Objection to the Derrybrien Windfarm Substitute Consent "Exceptional Circumstances" Application by the ESB PL07 308019-20

JULY 2021

The Project comprises 70 No. Vestas V52-850 kW wind turbines and substation, a grid connection comprising an overhead line (approximately 7.8km long) and Agannygal Substation connecting the wind farm to the National Grid and all associated developments. The owner and operator of the wind farm is Gort Windfarms Limited, a subsidiary of the Electricity Supply Board (ESB). Planning permissions were obtained between 1998 and 2002.

Figure 1: Contents of Appendices as listed in the Chapter 10 Main Chapter

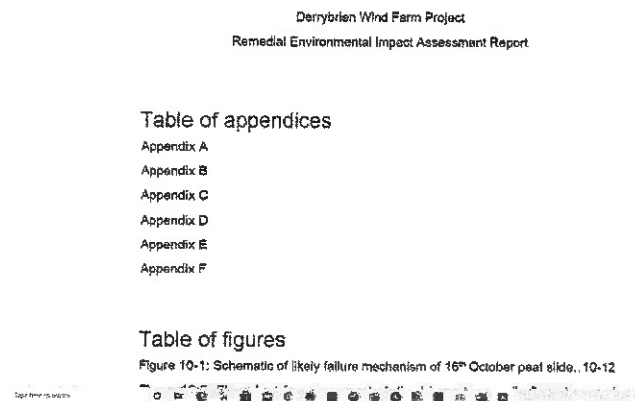
The rEIAS document provides a list of contents for the document itself, but provides no information in the Contents pages about what is contained within the Appendices (see attached Figure).

This provided list of Appendices suggests that there are six Appendices, A – F, but what these contain and what their significance might be is left to the reader to guess. Turning to the Appendix document itself (namely Chapter 10 – Soils, Geology and Land Appendices, Document No.: QS-000280-01-R460-001-000), this provides no Contents page or Index at all, other than the contents pages of the individual reports presented within the appendices – to which there is no guide at the start of the document. Furthermore, it emerges that there are not six Appendices but instead a nested multitude of Appendices, in some cases going down as far as four levels of Appendix.

Figure 1. Smooth face of a peat crack, or fissure, resulting from peat shrinkage caused by water loss from the peat matrix as a result of drainage. The face is aligned along a former forestry ploughing furrow. Photograph taken during a 2004 field investigation of the Derrybrien windfarm site.

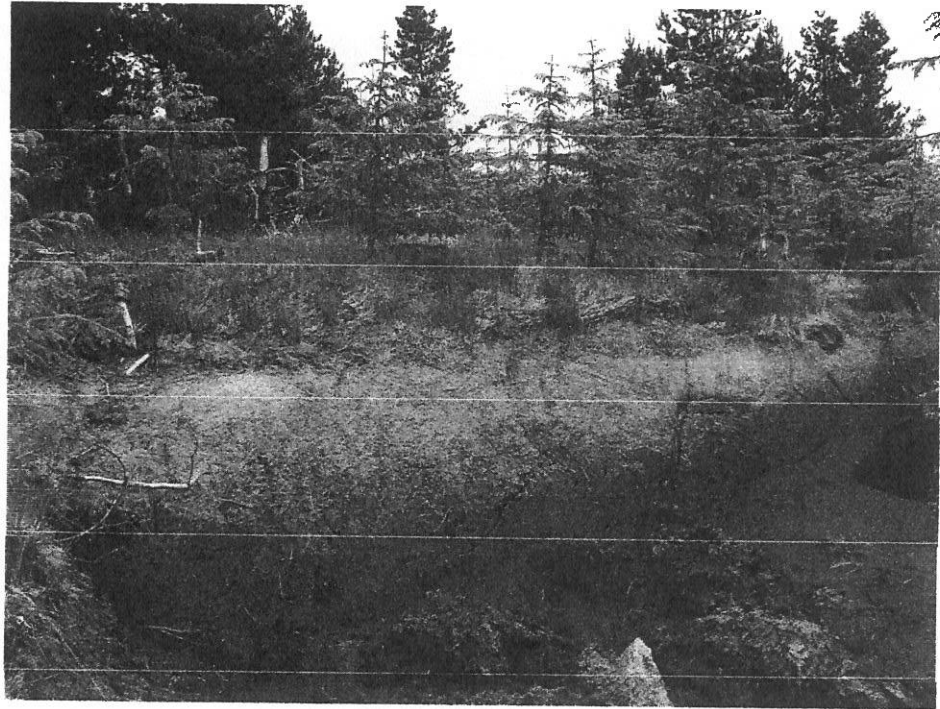
Nor is there a **map indicating location, extent and orientation of cracks, fissures, ridges or other pre-failure indicators**. That such cracks and fissures exist at Derrybrien is highlighted repeatedly by Lindsay & Bragg (2005), who emphasise that cracks can be found extensively throughout the forested areas (see Figure 1).

A key, indeed a critical, part of the Derrybrien rEIAS should therefore have been the mapping of all such cracks and fissure, but the rEIAS makes no mention of such cracking. As SGG-2017 observes: *“In preparing assessments of peat stability, developers should give afforested peatlands (which are often hydrologically disrupted and physically degraded) the same scrutiny as peatlands without forest, even if this may be more arduous in practice (due to concealment of the ground surface by tree cover and associated access difficulties).”*

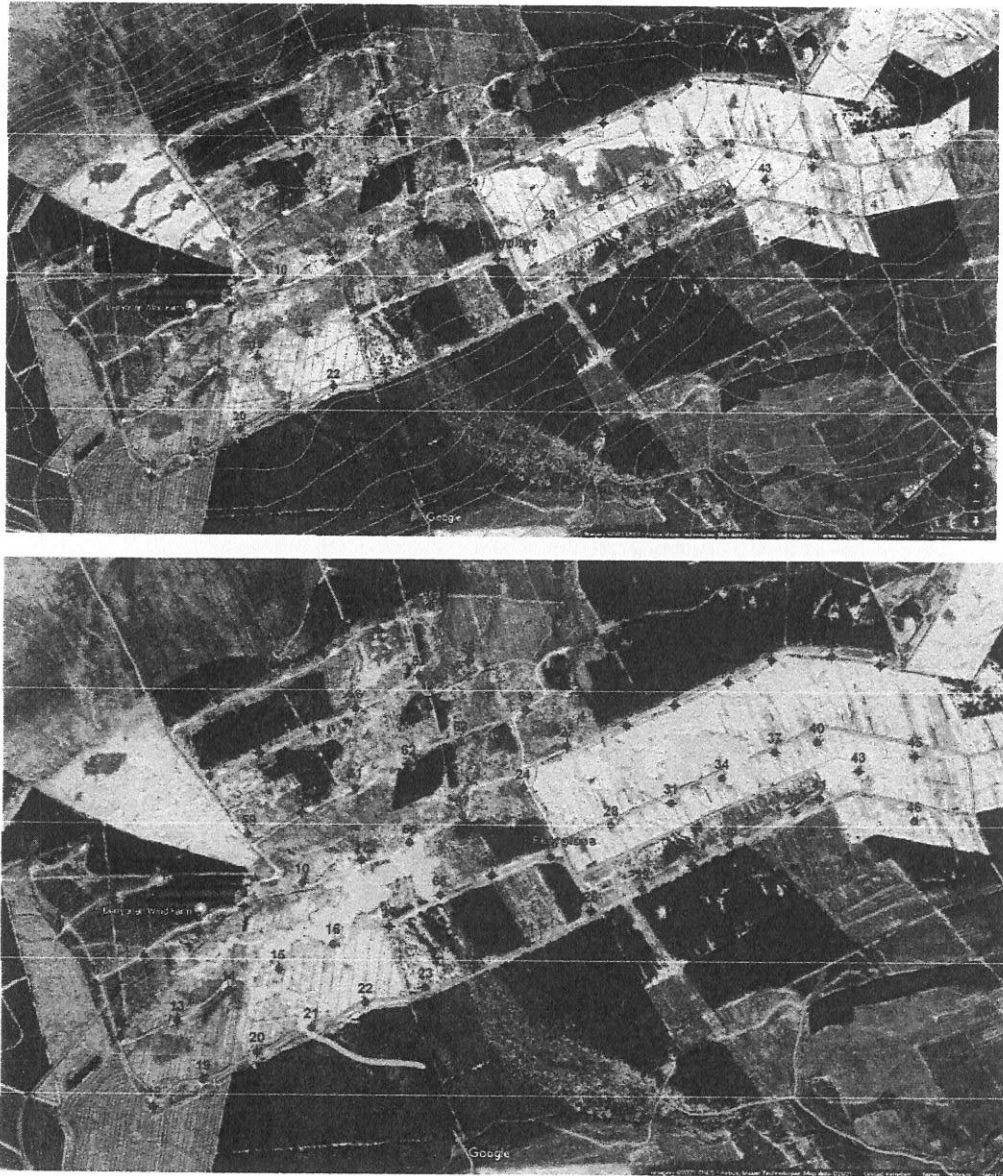
It seems likely that there is further failure in basic mapping of the ground condition in terms of how the information obtainable from aerial photography has been interpreted. With reference to the aerial photographs provided as ‘*Figure 10-4 in Section 10.2.1.3*’ of the rEIAS and ‘*Figure 2-1 of Appendix E*’, the latter figure points to a dark sinuous band of colour crossing the turbary area and describes it as ‘*deep peat along subsurface drainage channel*’ which is undoubtedly the case, given the sinuous nature of the dark shading.

A similar band of sinuous shading which forms a huge crescentic shape leading down into the same ‘shallow valley’ which experienced the 2003 peatslide (see Figure 2) is merely identified (along with others) as an ‘*Area of deeper peat and high water table on flat terraces (Darker vegetation)*’ but with no mention of the (very likely) possibility that this, too, is an area of sub-surface piping and/or seepage. Furthermore, the dark zones identified in the NW corner of the aerial photograph and lying just outside the windfarm boundary actually point downslope and converge on a natural drainage line, so it is possible that these, too, are seepage zones or areas of sub-surface piping.

Further areas of dark ground can just be discerned vanishing into the forest blocks within the windfarm site, so it is possible that sub-surface seepage is widespread within the site. These may be natural zones of seepage, but published evidence from, for example, Holden *et al.* (2002) and Holden (2005) have identified a clear linkage between drying peatlands and prevalence of sub-surface piping.

It should also be noted that the heads of the pale blue seepage zones in Figure 2 all begin along the line from Turbines 27 to Turbine 42.

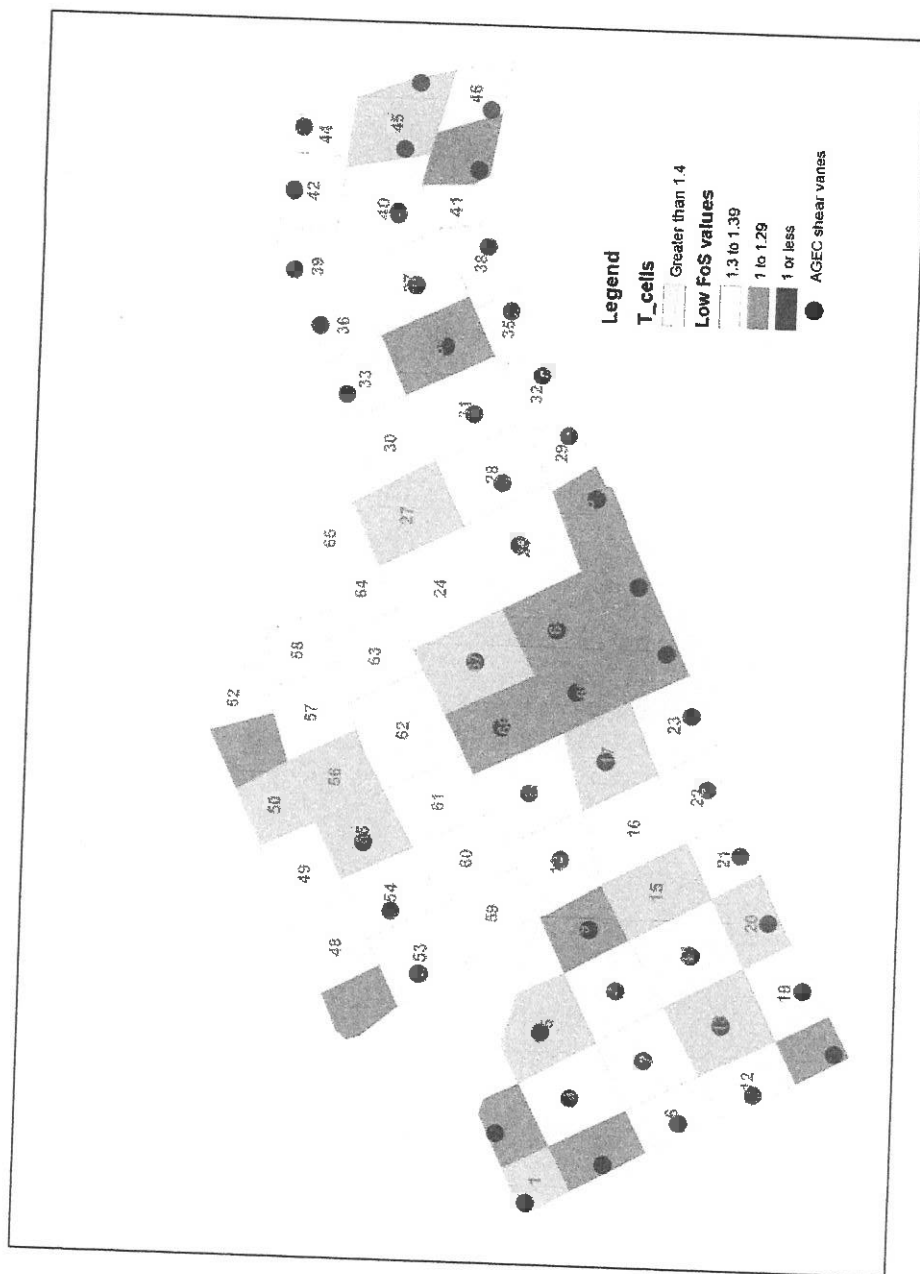
Secondly, the FoS calculation for each T-cell was based on testing the peat in only a single location in each T-cell, and even this in only a proportion of the full set of T-cells (see Figure 6).

Figure 8. Peat Stability Assessment by AGL (2020) for baseline conditions in 1998 for each T-cell. Highest risk rating is '5'. Note the concentration of high risk cells in the northern section of the site, and also the high risk value along the western margin of the site.

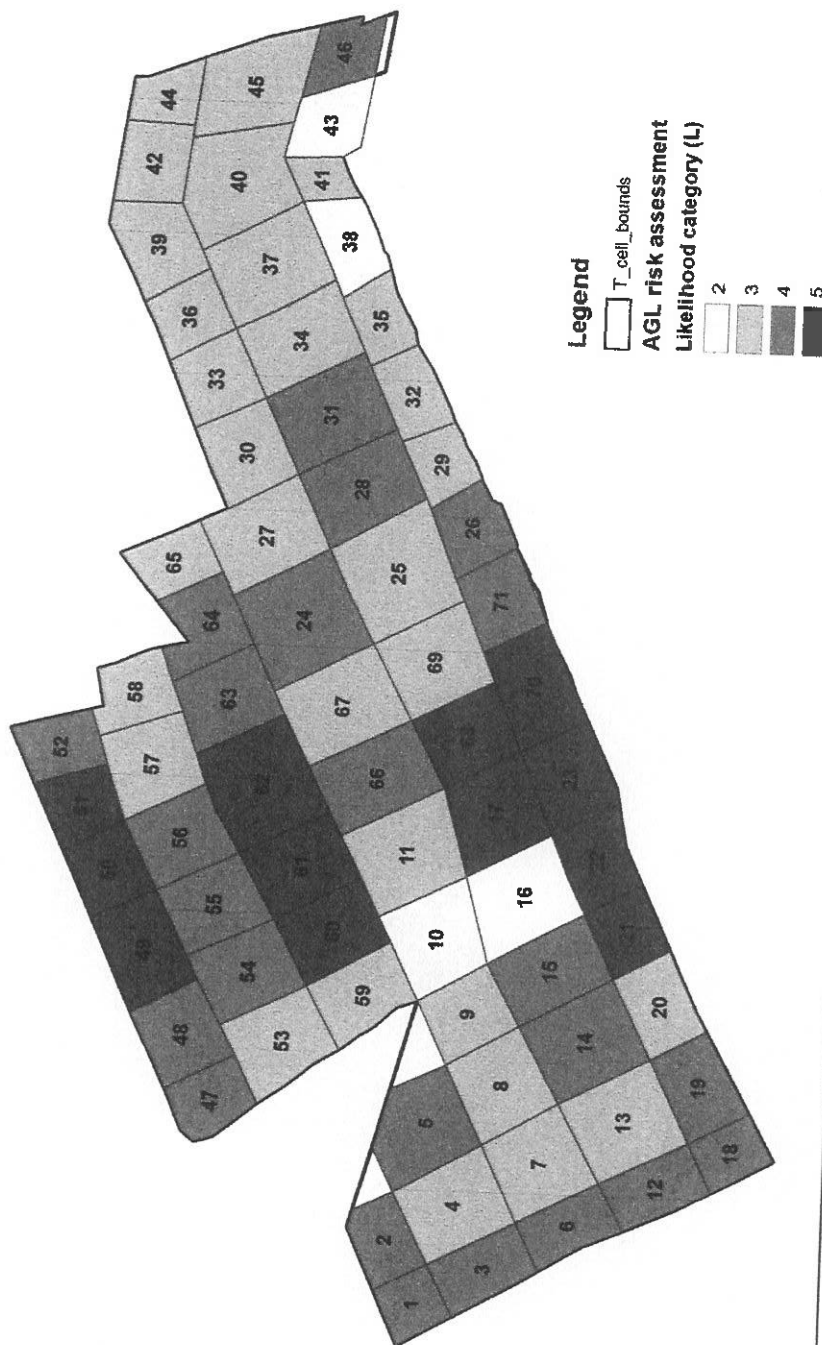
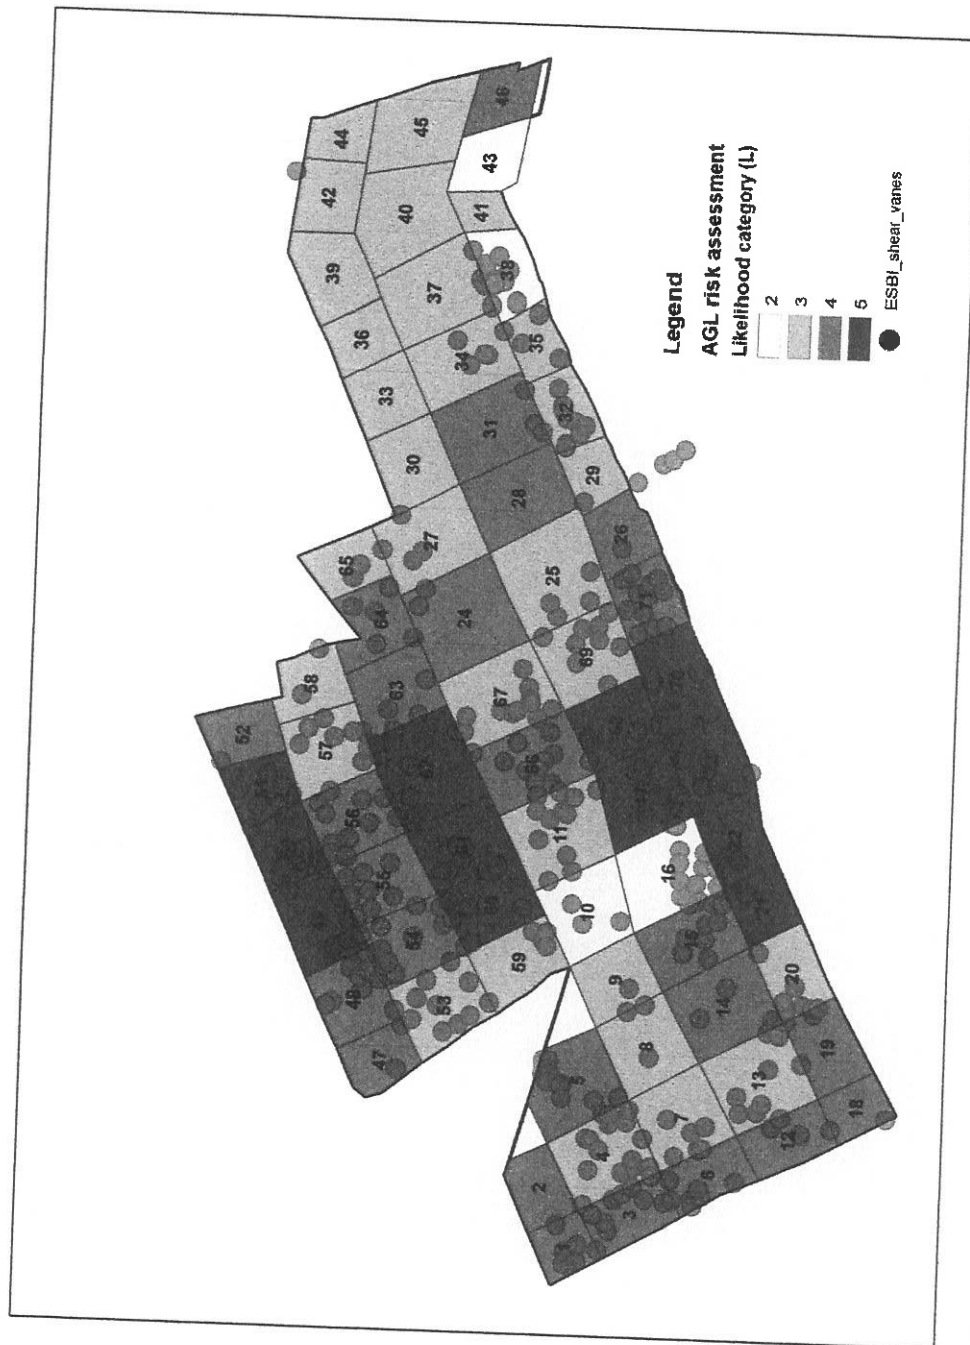
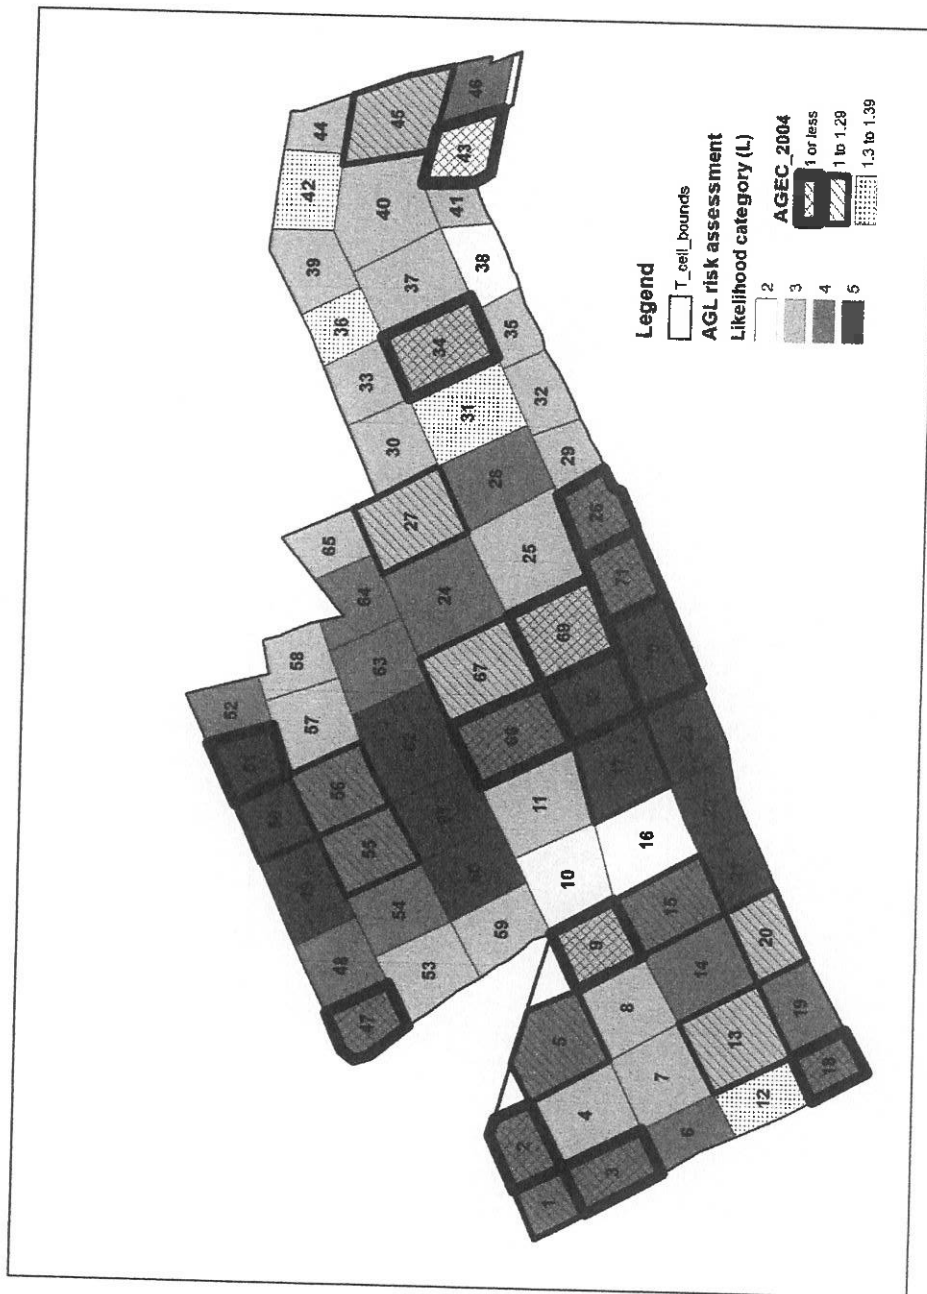
significant risk of instability and consequent impact (see Figure 8). The distribution of shear vane tests in relation to this assessment can be seen in Figure 9, while correspondence with the original 'worst-case' map generated by AGECE (2004) can be seen in Figure 10.

What is most striking about the areas identified as being at risk in by AGECE (2020) is the clear concentration of T-cells at risk in the northern sector of the site, mirroring the already-failed area of the 2003 slide to the south. This region remained largely un-surveyed by AGECE (2004) so the main records for peat condition come from ESBI (2005). Even after this survey, however, some critical T-cells remain largely un-tested, as can be seen from Figure 9. They still emerge as being significantly at risk because of other risk factors. Concentration of high-risk areas in the northern and western parts of the site is reinforced by the findings of the AGECE (2004) report, as can be seen in Figure 10.

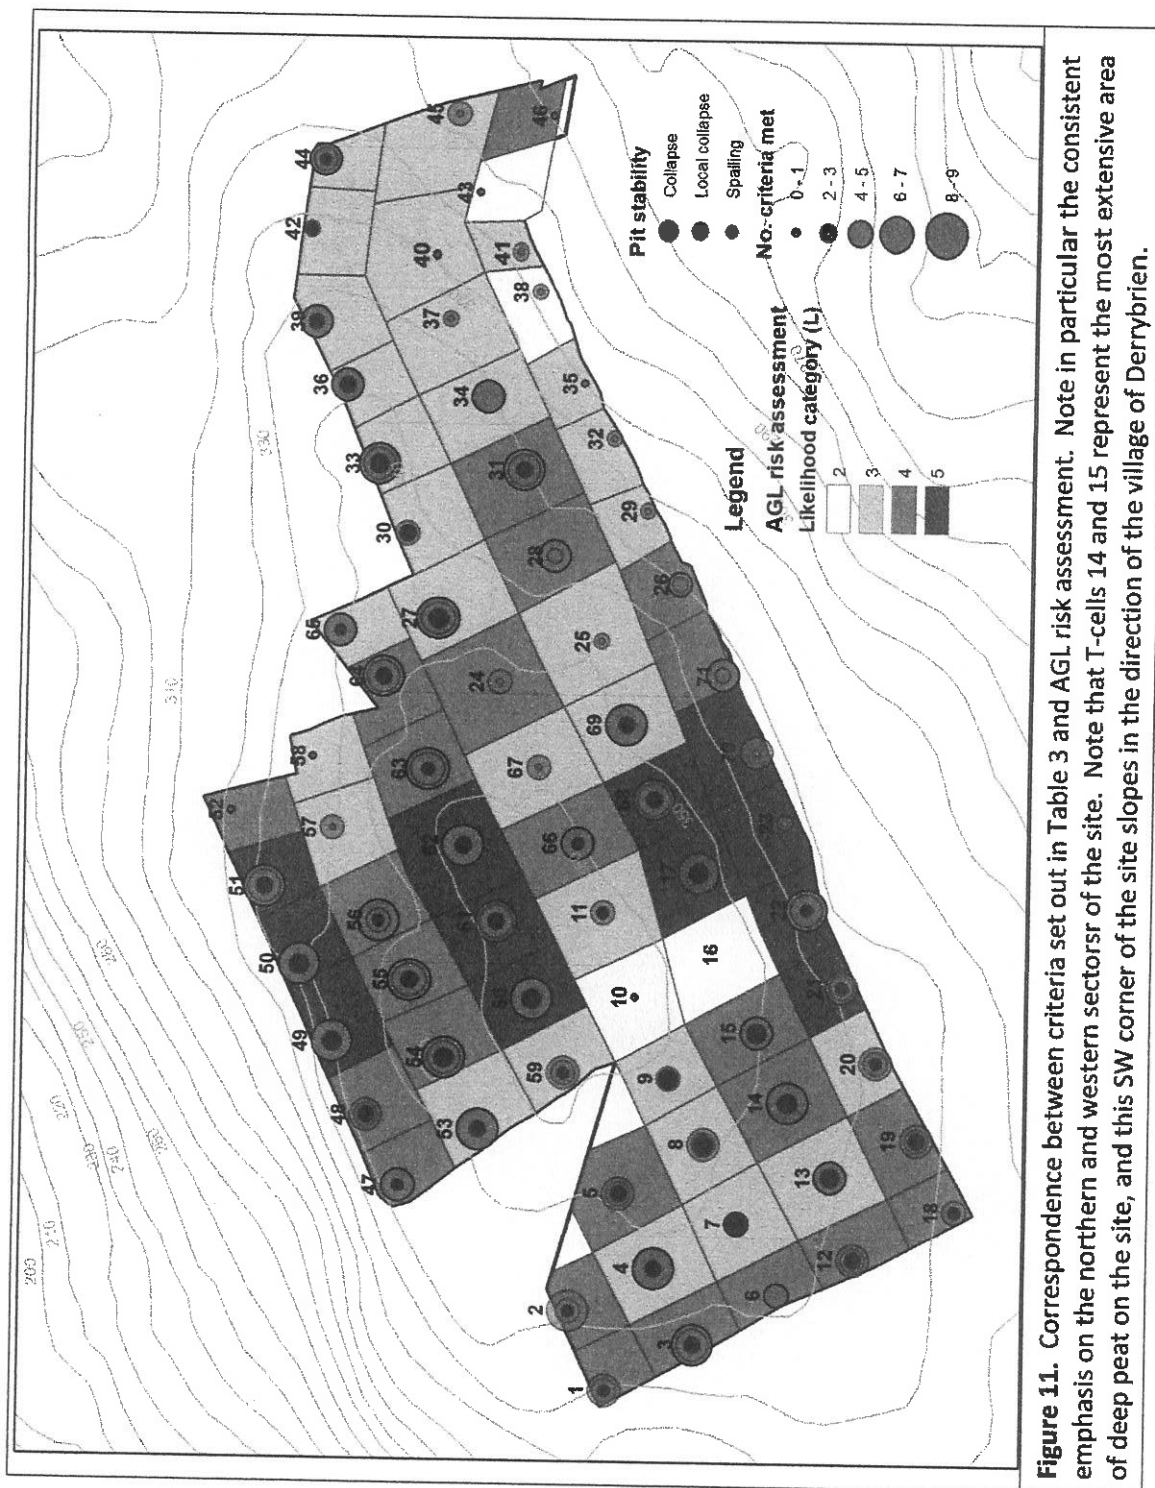
Furthermore, 'Figure 3-7, Appendix B' indicates several areas where forestry will be left in place despite the general requirement for forestry to be removed when a windfarm is constructed. No reason is given for the retention of these forest blocks but their somewhat irregular edges suggest that they have been left in place because of local ground conditions rather than being planned forest coups. Their concentration in the northern part of the site, across areas consistently indicated as being at risk, would lend weight to the conclusion that this ground has shown sufficient signs of instability to abandon forest operations.
